Smart Construction Retrofit v1.5.8 Update

Controller for AT03 model does not FIX stably

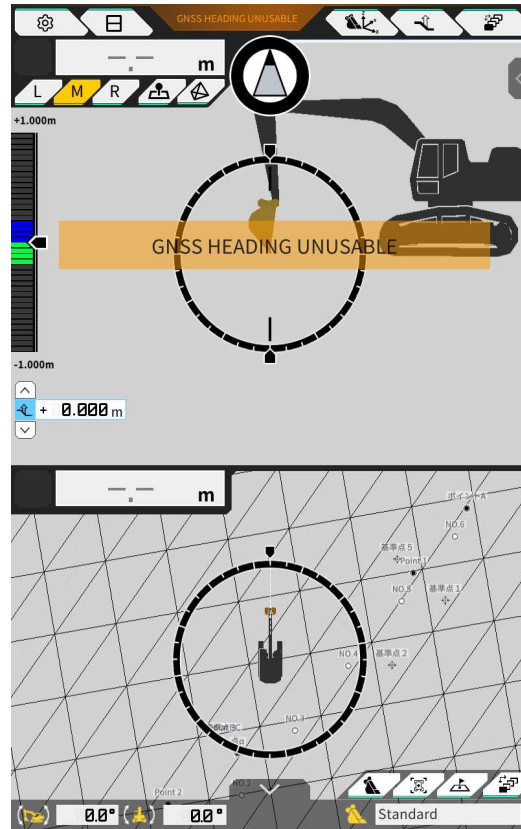
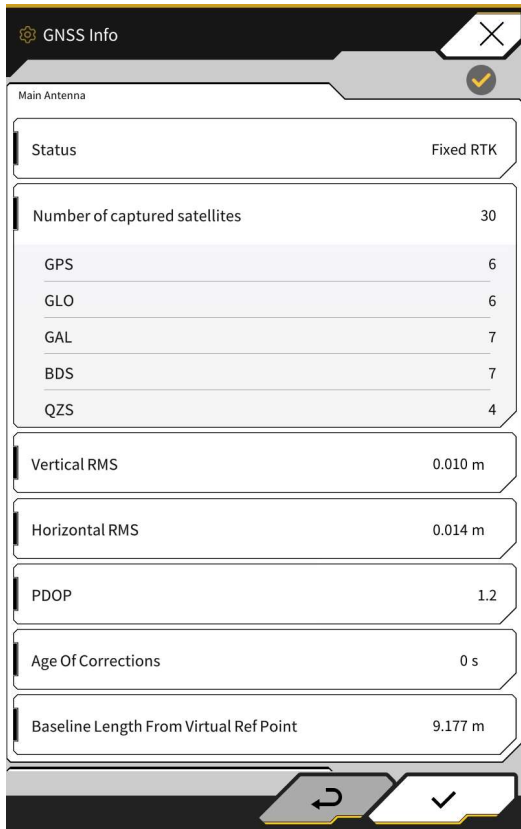
A problem with the controller model SCRF00AT03, displayed "GNSS Heading Unusable" and could not be used stably, has been addressed in v1.5.8.

GNSS is Fixed RTK but "GNSS Heading Unusable" does not disappear and stable operation is not possible.

For controllers with PRODUCT NAME "**SCRF00AT03**", please update the FW using Pilot UPD. Initialization of the configuration file is not required.
